Access Compliance Report Public Rights-of-Way (Curb Ramps)

Main Street: N_DAISSY_ST		Cross Street: N/A		Location:	SW
ADA ID: RPRK211202114532	Ramp Type: Type 4 - Parallel	Initial Pass/Fail: Fail	Overall Compliance: No	Severity Score:	16
Codes/Mitigation Info/Possible Solution			Field Measurements/Component Compliance

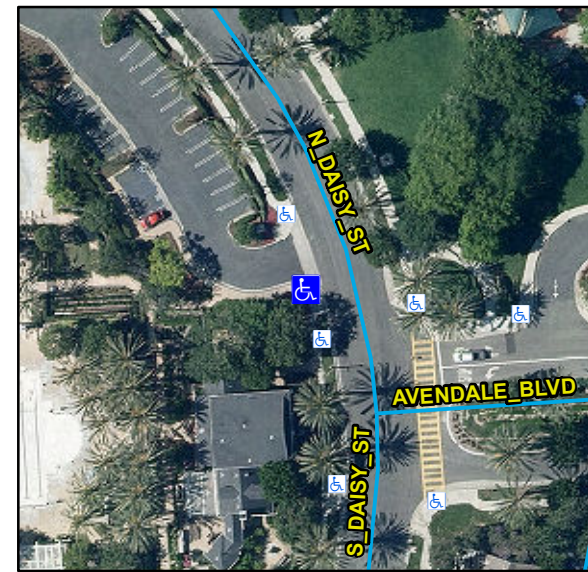
Compliance	Description	Data	Compliance	Description	Data
N/A	Ramp Length LT (in)	104	N/A	Ramp Length RT (in)	104
Yes	Ramp Width LT (in)	89	Yes	Ramp Width RT (in)	89
Yes	Ramp Run Slope LT (%)	2.4	No	Ramp Run Slope RT (%)	9.5
No	Ramp Cross Slope LT (%)	4.4	Yes	Ramp Cross Slope RT (%)	1.9
N/A	Landing Present	N/A	N/A	DWS Provided	N/A
N/A	Landing Length (in)	N/A	N/A	DWS Contrast	N/A
N/A	Landing Width (in)	N/A	N/A	DWS Length (in)	N/A
N/A	Landing Run Slope (%)	N/A	N/A	DWS Full Width	N/A
N/A	Landing Cross Slope (%)	N/A		DWS Offset Type	N/A
N/A	Landing Movement Obstructed?	N/A	N/A	DWS Offset Left (in)	N/A
	Landing Movement Type	N/A	N/A	DWS Offset Right (in)	N/A
N/A	Landing Shared	N/A			
N/A	Clear Space	Yes			
N/A	Clear Space To Crosswalk (in)	N/A			
N/A	Marked Crosswalk 1	No	N/A	Marked Crosswalk 2	No
	Crossing 1 Direction	E		Crossing 2 Direction	N
	Marked Crosswalk 1 Width (in)	N/A		Marked Crosswalk 2 Width (in)	N/A

Remove & Replace Curb Ramp With Two New Directional Ramps or Equivalent.
